Access Compliance Report Public Rights-of-Way (Curb Ramps)

Main Street: STERLING_GLEN Cross Street: SHELTON_CT Location: NW

ADA ID: RPAT211101135638 Ramp Type: Type 4 - Parallel Initial Pass/Fail: Fail Overall Compliance: No Severity Score: 32

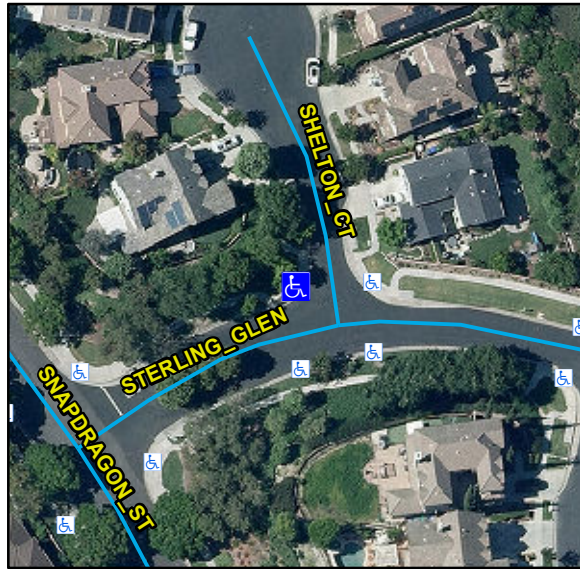
Compliance	Description	Data	Compliance	Description	Data
N/A	Ramp Length LT (in)	112	N/A	Ramp Length RT (in)	93
Yes	Ramp Width LT (in)	54	Yes	Ramp Width RT (in)	54
Yes	Ramp Run Slope LT (%)	5.4	No	Ramp Run Slope RT (%)	12.9
No	Ramp Cross Slope LT (%)	3.1	No	Ramp Cross Slope RT (%)	2.5
N/A	Landing Present	N/A	N/A	DWS Provided	N/A
N/A	Landing Length (in)	N/A	N/A	DWS Contrast	N/A
N/A	Landing Width (in)	N/A	N/A	DWS Length (in)	N/A
N/A	Landing Run Slope (%)	N/A	N/A	DWS Full Width	N/A
N/A	Landing Cross Slope (%)	N/A		DWS Offset Type	N/A
N/A	Landing Movement Obstructed?	N/A	N/A	DWS Offset Left (in)	N/A
	Landing Movement Type	N/A	N/A	DWS Offset Right (in)	N/A
N/A	Landing Shared	N/A			
N/A	Clear Space	Yes			
N/A	Clear Space To Crosswalk (in)	N/A			
N/A	Marked Crosswalk 1	No	N/A	Marked Crosswalk 2	No
	Crossing 1 Direction	S		Crossing 2 Direction	E
	Marked Crosswalk 1 Width (in)	N/A		Marked Crosswalk 2 Width (in)	N/A

N/A	Ramp Inside Crosswalk 1	N/A	N/A	Ramp Inside Crosswalk 2	N/A
	Crossing 1 Slope (%)	1.8		Crossing 2 Slope (%)	6.2
	Crossing 1 Cross Slope (%)	6.7		Crossing 2 Cross Slope (%)	4.5
N/A	Gutter Ponding	N/A	N/A	Curb Slope	11.5
Yes	Gutter Lip Height (in)	0		Road Run Slope (%)	5
N/A	Gutter Run Slope (%)	N/A		Road Cross Slope (%)	3.4
N/A	Gutter Cross Slope (%)	N/A	No	Perpendicular Joint Present	No
Yes	Overall Surface Condition	Acceptable			
	Cross Gutter Present?	No		Spandrel Present?	No
	Replace Cross Gutter?	N/A		Replace Spandrel?	N/A

Remove & Replace Curb Ramp With Two New Directional Ramps or Equivalent.

R204.3, R304.5.3, R304.3.2, STD 1115
